ARCHITECTURAL REVIEW FINDINGS AND DECISION

**** APPROVAL WITH CONDITIONS ****

Case #: AR-15-0025
Project: Cracker Barrel at Nyberg Rivers
Location: [7665 SW Nyberg St.](#) (Tax Lot 2S1 24AD 3100)
Applicant: LD Reeves and Associates, Inc.; Loretta Reeves, 1889 Manzana Ave, Punta Gorda, FL 33950
Project Contact: DOWL; Read Stapleton, rstapleton@dowl.com; 720 SW Washington St, Ste 750, Portland, OR 97205 (971) 280-8641

C2.0

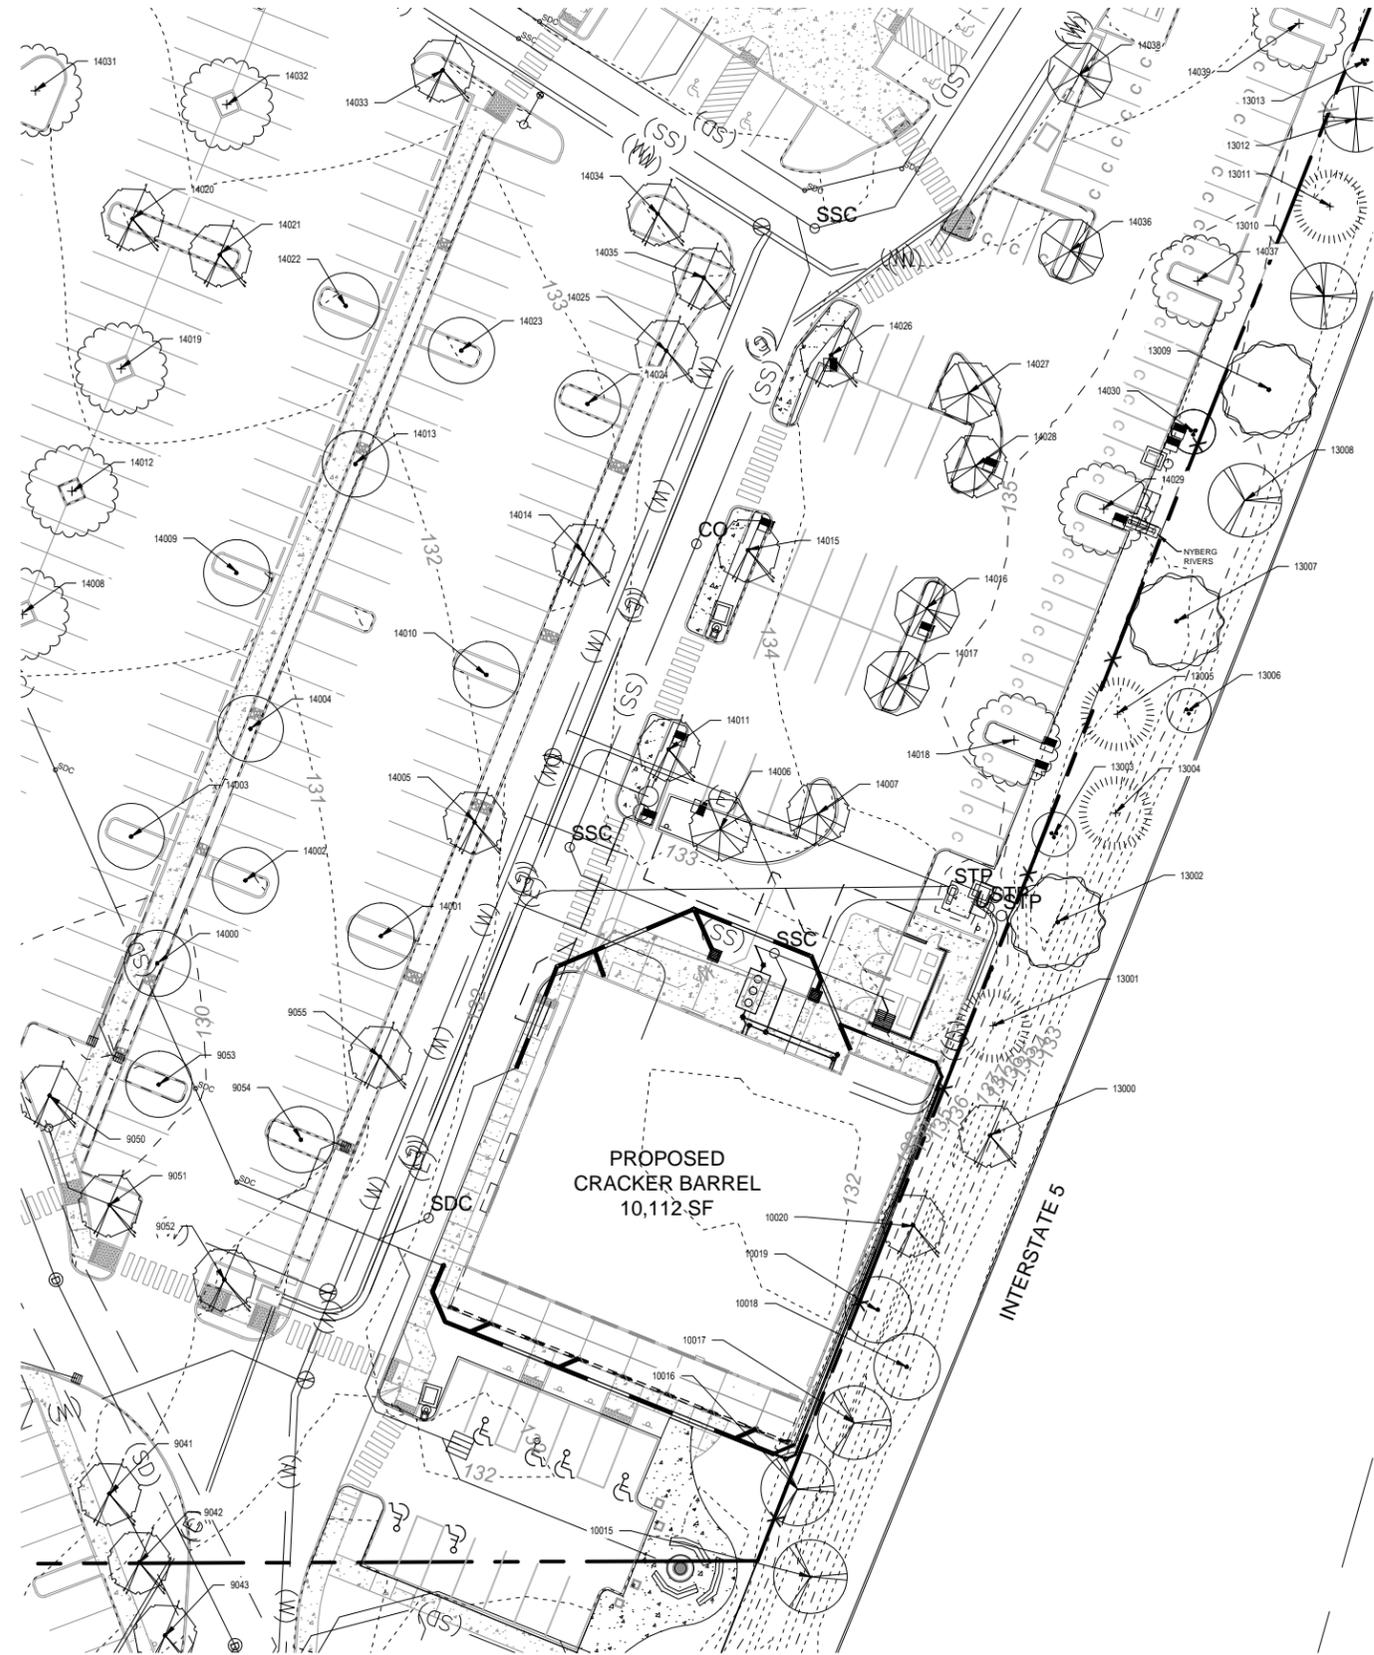
Applicant's Response: As shown on the Site Plan (Sheet C2.0), curb ramps are provided wherever a walkway or accessway crosses a curb.

Staff notes that bike parking is proposed behind the trash enclosure located on the northeast corner of the subject site. Staff has conditioned the applicant to provide bicycle access to the proposed bike parking area.

The applicant has demonstrated compliance with ADA standards on the Site Plan (Sheet C2.0). This standard will be met through the building permit process.

Applicant's Response: As shown on the attached Site Plan (Sheet C2.0), no section of parking stalls exceed eight continuous stalls in a row without a landscape separation.

Four ADA compliant parking spaces are provided at the south side of the building as shown on the Site Plan (Sheet C2.0).

Condition of Approval: Applicant shall submit revised site plans to provide bicycle access north of the trash enclosure to the bike parking area and install access according to revised plans.

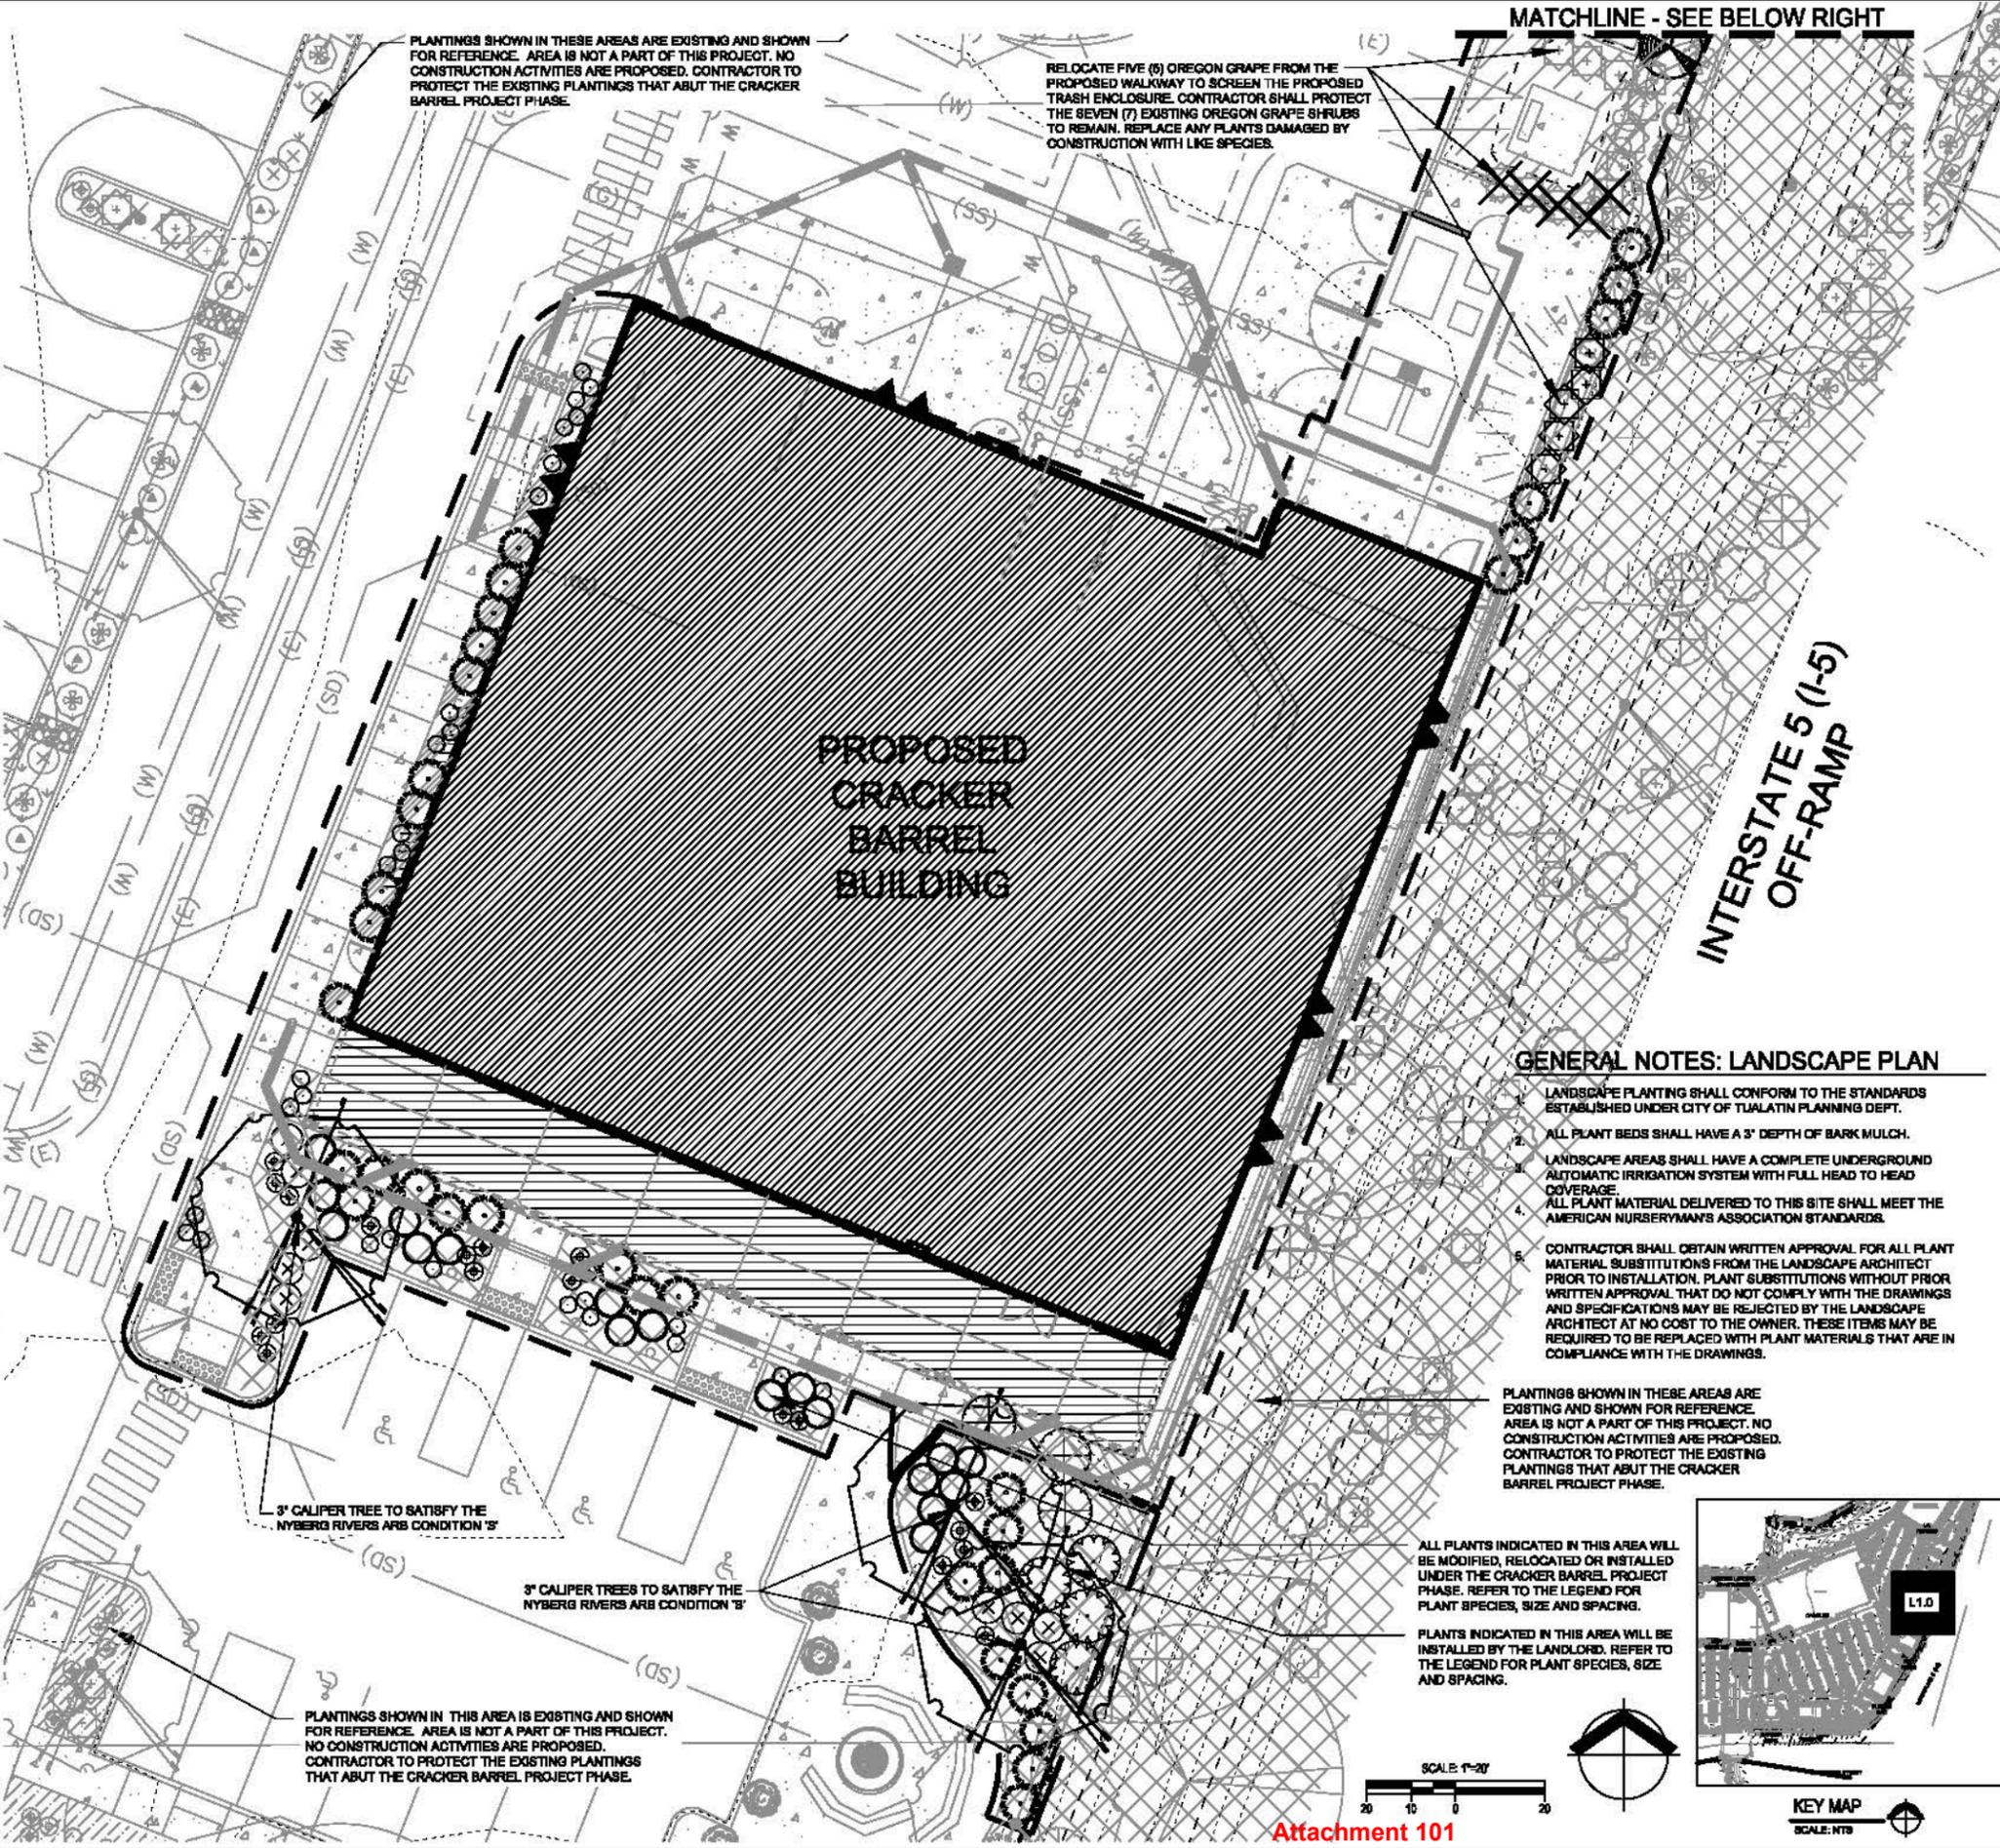
Staff notes that Douglas Spirea is proposed near the parking area located to the south. As these shrubs reach a mature height of six ft, staff is conditioning the applicant to provide landscaping that meets the vision clearance requirement near parking.

Staff notes that the applicant is proposing the use of shrubs that grow up to 3 ft tall in order to screen the transformer. Applicant shall be conditioned to provide adequate landscaping to fully screen the transformer on the north, east, and south side at time of planting.

As shown on the Landscape Planting Plan (Sheet L1.0), the overall landscape percentage provided for the proposed developed area is 4%.

Native plants including: Douglas Spiraea, Woods' Rose, and Pacific Ninebark are proposed for use throughout the landscaped areas (Sheet L1.0). This standard is met.

Condition of Approval: Applicant shall submit revised landscaping plans that note shrubs in parking areas must not exceed 30 inches in height and tree canopies must not extend below 8 ft measured from grade.

Condition of Approval: Applicant shall submit revised landscape plans that fully screen the north, east, and south side of the transformer at time of planting and install landscaping according to revised plans.
